Flight Procedures Cover Page	Task Action: Abbreviated Amendment	Task Type: IAP		APWS Task ID: E9EE8D2A0E094259A294A5C3E13F4B71	APWS Project ID: 440CFA2977C84BD1A0EAB18F755021F0
Procedure: ILS OR LOC RWY 3 AMDT 1C		Enroute: NO	Specialist: Smart, Phillip		Agreement Number:
Airport ID: KCHO			Airport City: CHARLOTTESVILLE		State: VA
Facility ID:	Facility Type:	Flight Inspection Remark Type:

## **Procedure Comments:**

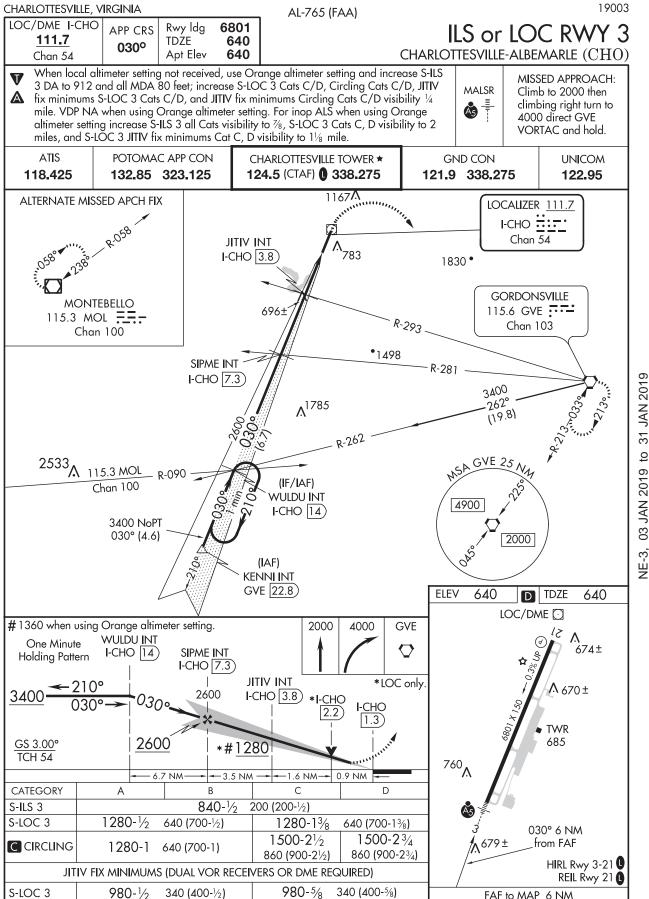
Corrected the VOR radial on the alternate missed approach instructions.
